DEVELOPMENT MANAGEMENT AGENDA

ADDENDUM SHEET

22/03760/FHA One and a half storey rear extension including room in roof space, extension to existing side dormer, re-roof with new tiles, reconstruct attached garage to side and installation of new doors and windows

29 Langley Hill, Kings Langley, Hertfordshire, WD4 9HA

BALCONY PROPOSAL FOR 29 LANGLEY HILL: (GLASS BALCONY: 5M. WIDE)

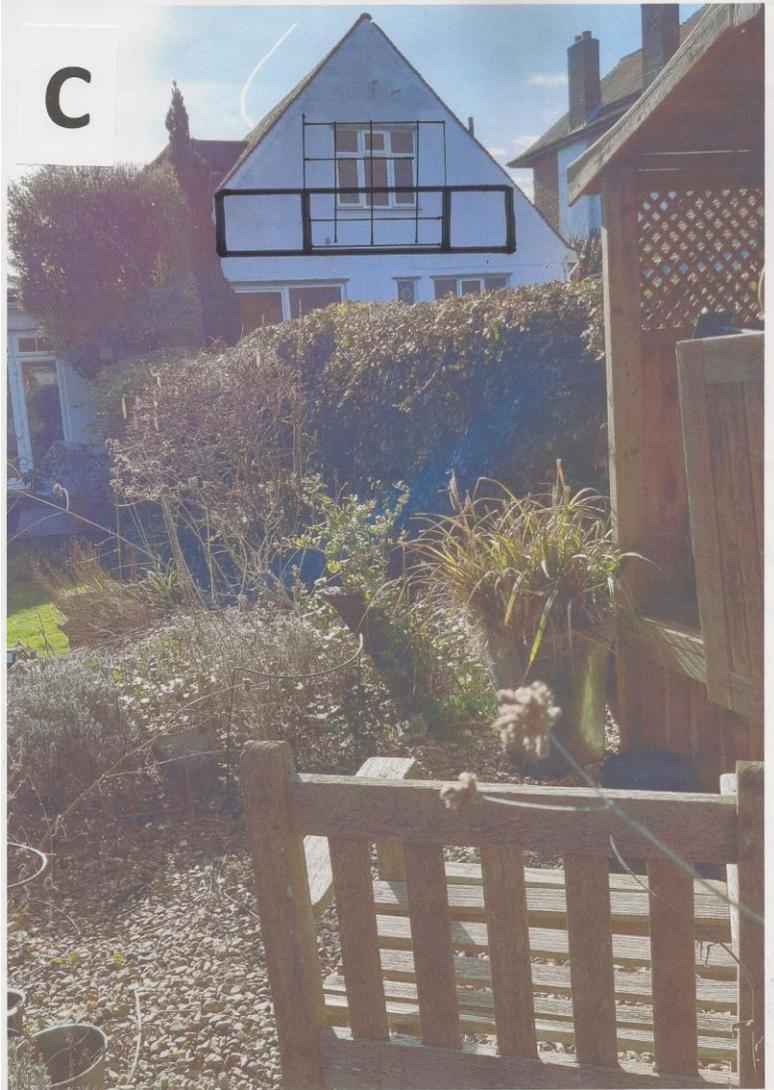
We strongly object to this statement, as the highly elevated balcony will be extremely prominent, regardless of being inset, measuring 5 metres in width and due to the changes in level, will be 5.5 to 6 metres in height, from the hand rail to our adjacent lawn levels! The inset design, still allows our neighbours to stand on the balcony, and have a full 180 degree view over both our garden and number 31's garden. The fact that it is extended right across the full width of the extension, with a glass balustrade, and that it will be so elevated, means that the views are far, far wider than those of the existing window and it will directly overlook our garden and the neighbours on the other side at no31. The double glass doors leading to the balcony are nearly three times, the size of the existing window. It will cause visual intrusion and we will suffer a huge loss of privacy in our

- A. Shows how the huge width, extent and style of the proposed glass fronted balcony on 29 Langley Hill will appear.
- B. This plan shows the huge overlooked area from this elevated 1st floor balcony. It shows that wherever, we sit in the garden, we will be constantly overlooked by the balcony. The diagram shows, that due to the height of the balcony, even the fence offers no privacy, as the views from no 29 look way over the top of a 1 metre fence.
- C. Shows the same, and the extent of the views when standing on the balcony, looking out, despite it being inset.
- D. Again, this shows the extent of our garden which will be overlooked. It also illustrates the height of this proposed balcony, as the main extension, will be 1 /1.5 metres above our ground levels, resulting in a huge loss of privacy. Levels have not been considered in the design of this extension.

3a

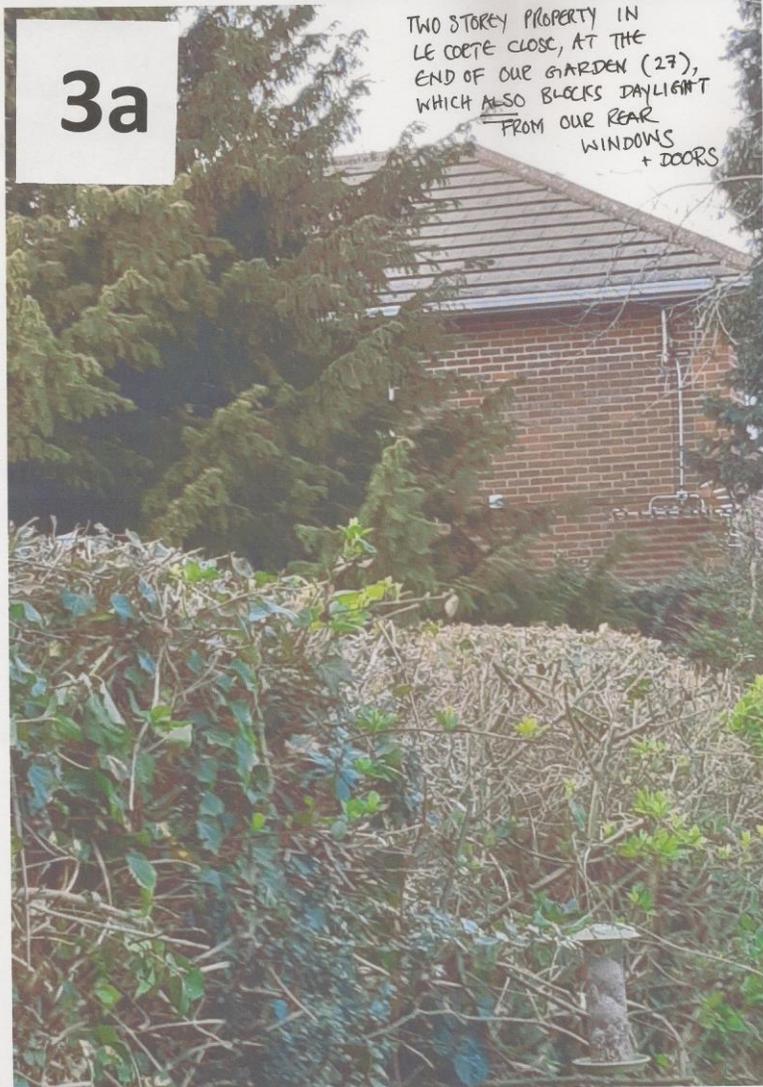
3a. This shows how we already suffer from a loss of light, from an elevated 2 storey house to the rear in Le Corte Close.

TWO STOREY PROPERTY IN
LE COETE CLOSE, AT THE
END OF OUR GARDEN (27),
WHICH ALSO BLOCKS DAYLIGHT
FROM OUR REAR
WINDOWS
+ DOORS

3b

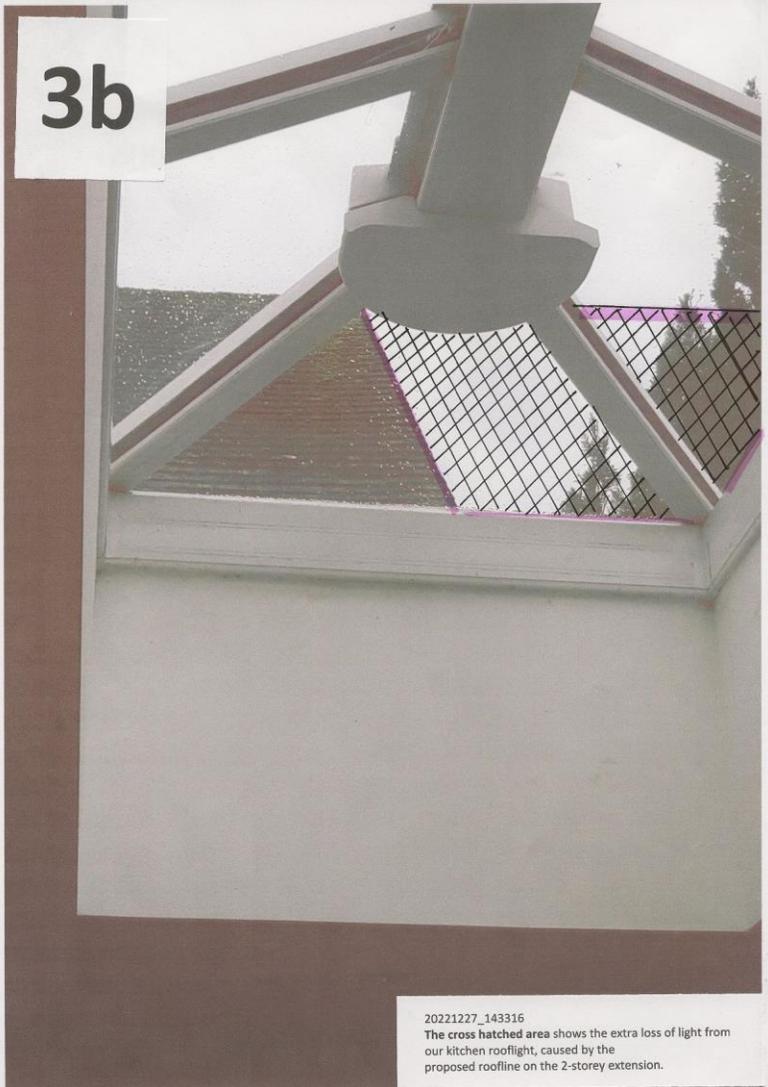
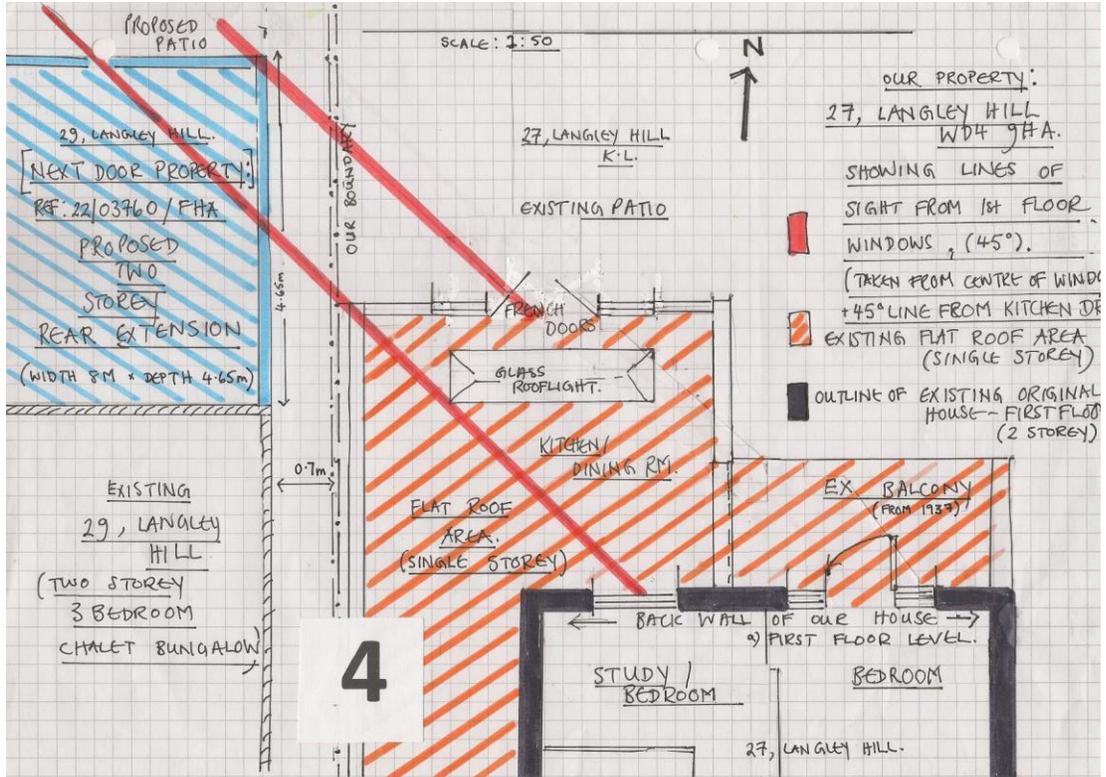
3b. This shows how the proposed extension will cut further light from the rooflight in our kitchen/dining area.

20221227_143316
The cross hatched area shows the extra loss of light from our kitchen rooflight, caused by the proposed roofline on the 2-storey extension.

5

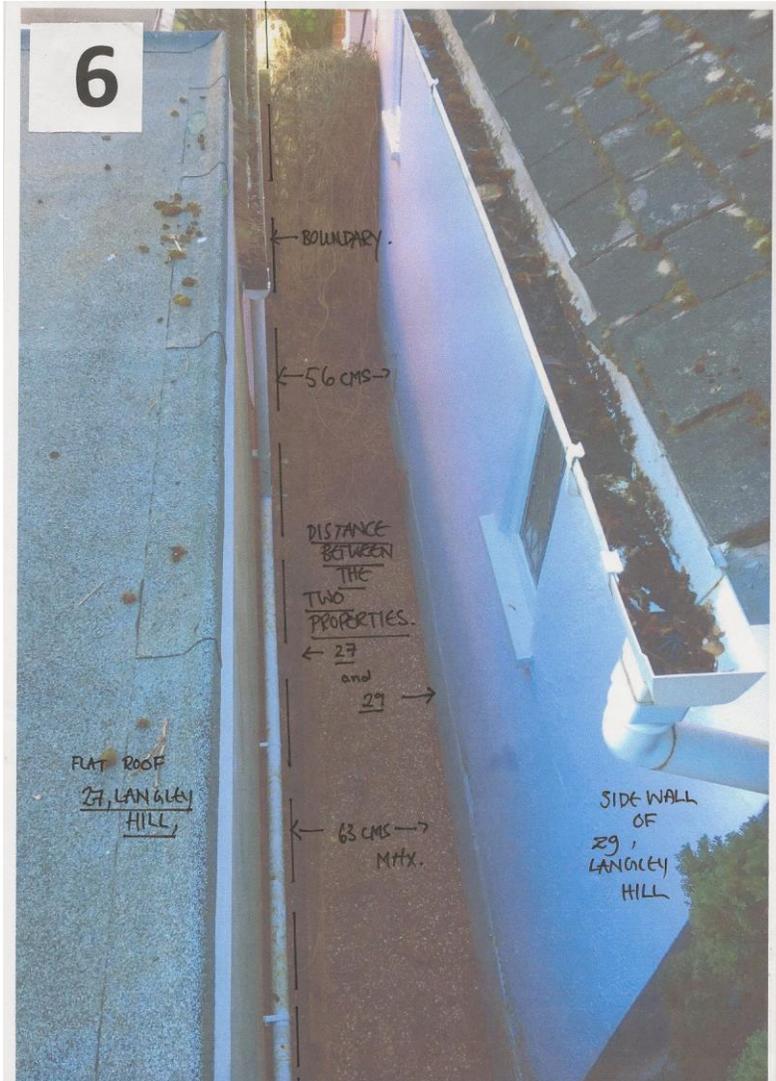
5. Shows the existing side access gate, from the back garden of number 29 to the side driveway and front garden. This access will be removed if the extension is granted permission. See item no 6 below. The planning officers report states, in the PROPOSAL, that “ the attached garage will be reconstructed” . PLEASE NOTE: It is currently not an attached garage. It is a detached garage with a side access gate.

CURRENT
DETACHED
GARAGE/STORE
AND SIDE ACCESS GATE
